Office Action Summary	Application No. 10/696,587	Applicant(s) WIRTH ET AL.	
	Examiner Phong H. Nguyen	Art Unit 3724

DETAILED ACTION

See Fig. 1.

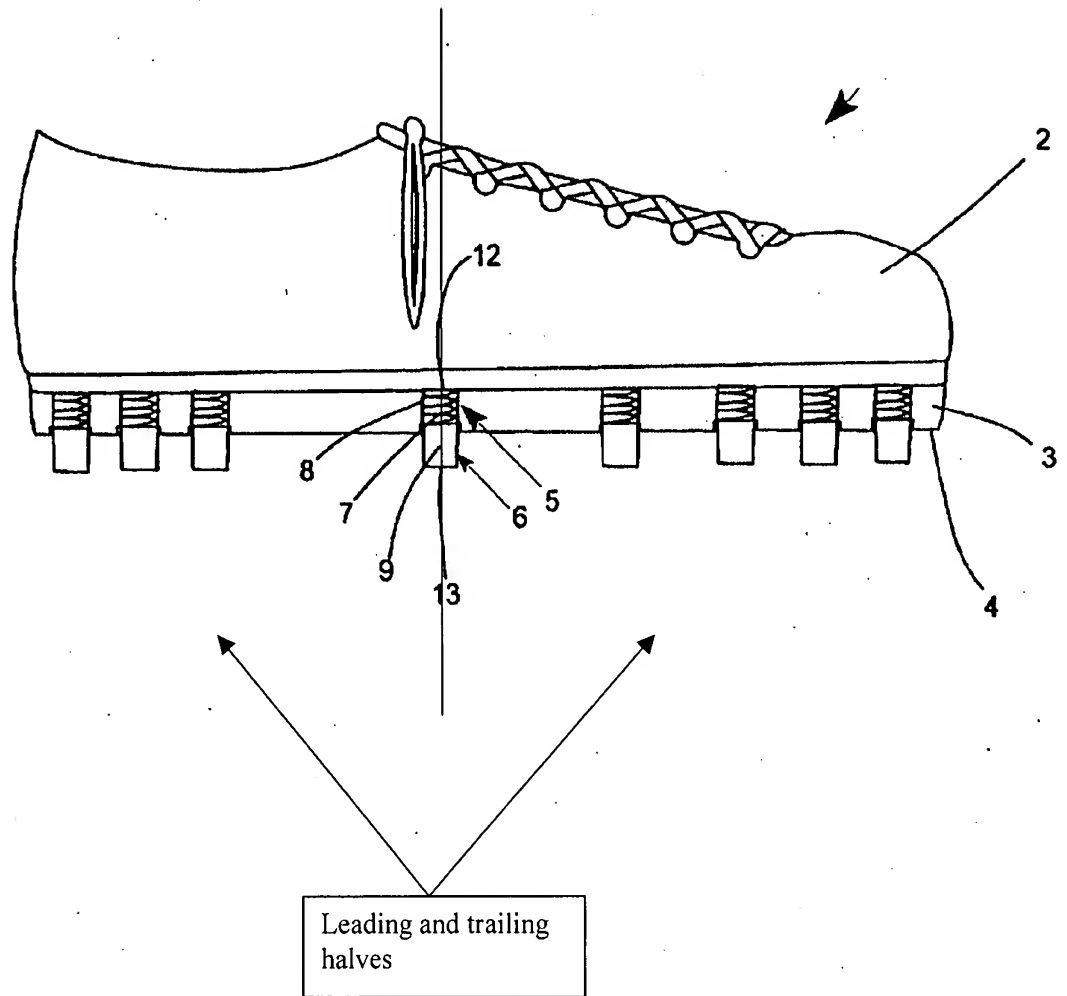
Regarding claims 1-4, Sizemore teaches a shoe capable of being used as a push block device for displacing a workpiece relative to woodworking equipment, comprising: a main body having a proximal end, a distal end, a longitudinal axis, and a first, generally flat working surface 4; a handle component 2 extending from the main body whereby

when the first working surface is disposed in parallel facing relation to a top surface of a workpiece, the handle component is disposed predominantly vertically above the main body; and a heel component 6 extending from the main body so as to have a first, operative position, wherein the heel projects vertically below a first plane of the first working surface, and a second, stored position wherein the heel is disposed in or vertically above the first plane, the heel defining a second working surface disposed in a second plane defined at an angle with respect to the first working surface.

Regarding claim 11, the retention plate (the plate on the top of element 3) is best seen in Fig. 1.

Regarding claim 12, element 3 is considered a slip resistant pad since it is made of rubber. See Fig. 1 and col. 2, lines 47-55.

Regarding claim 15, see attached Fig. 1.

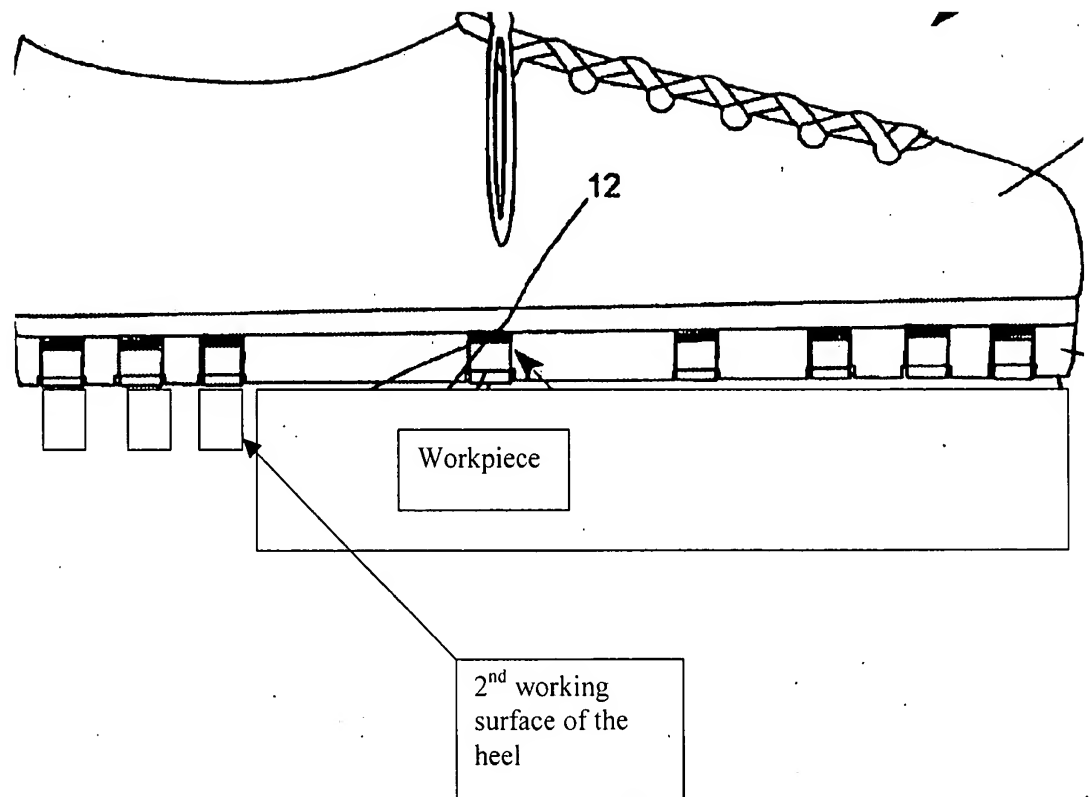
Although the Sizemore's shoe is not a push block, it is capable of being used to push a workpiece. Sizemore teaches a second working surface capable of engaging a trailing surface of a workpiece for advancing the workpiece. See below sketch.
